Access Compliance Report

Public Rights-of-Way

(Curb Ramps)

Intersection ID: 54454	Main Street: COLLINGHAM_DR	Cross Street: STEELE_CREEK_RD	Location: NW
ADA ID: 47F5B56CE9F2	Ramp Type: Perp	Initial Pass/Fail: Fail	Overall Compliance: No
Severity Score: 26.25			
Codes/Mitigation Info/Possible Solution		Field Measurements/Component Compliance

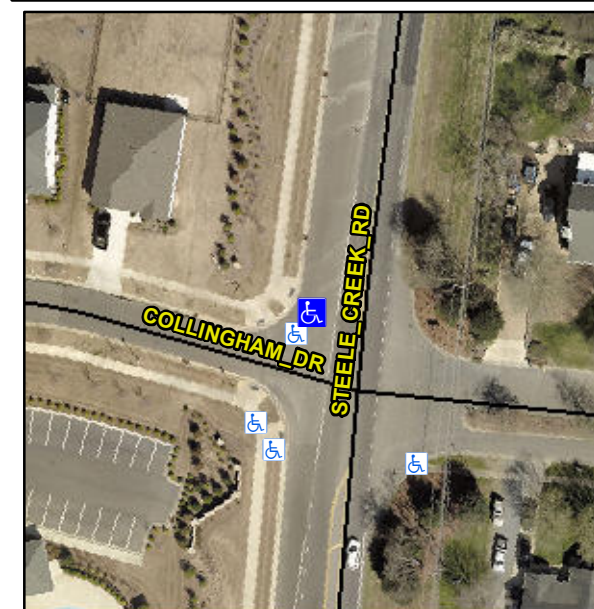
R304.2.2, R304.5.3

Compliance	Description	Data	Compliance	Description	Data
N/A	Ramp Length (in)	96.0	No	Ramp Slope (%)	12.1
Yes	Ramp Width (in)	52.0	No	Ramp XSlope (%)	2.6
N/A	Flare Type LT	N/A	N/A	Flare Type RT	N/A
N/A	Flare Slope LT (%)	N/A	N/A	Flare Slope RT (%)	N/A
N/A	Flare Traversable LT?	N/A	N/A	Flare Traversable RT?	N/A
N/A	Landing Length (in)	N/A	N/A	DWS Provided?	N/A
N/A	Landing Width (in)	N/A	N/A	DWS Contrast?	N/A
N/A	Landing Slope (%)	N/A	N/A	DWS Length (in)	N/A
N/A	Landing X Slope (%)	N/A	N/A	DWS Full Width?	N/A
N/A	Landing Curb? (Y/N)	N/A	N/A	DWS Offset (in)	N/A
N/A	Shared Landing?	N/A			
N/A	Gutter Ponding?	N/A	N/A	Gutter Slope (%)	N/A
N/A	Gutter Lip Ht (in)	N/A	N/A	Gutter X Slope (%)	N/A
N/A	Painted X Walk1?	No	N/A	Painted X Walk2?	N/A
	X Walk 1 Direction	To SE		X Walk 2 Direction	N/A
N/A	X Walk 1 Width (in)	N/A	N/A	X Walk 2 Width (in)	N/A
	X Walk 1 Slope (%)	4.8		X Walk 2 Slope (%)	N/A
	X Walk 1 X Slope (%)	0.8		X Walk 2 X Slope (%)	N/A

Remove & Replace Entire Ramp.
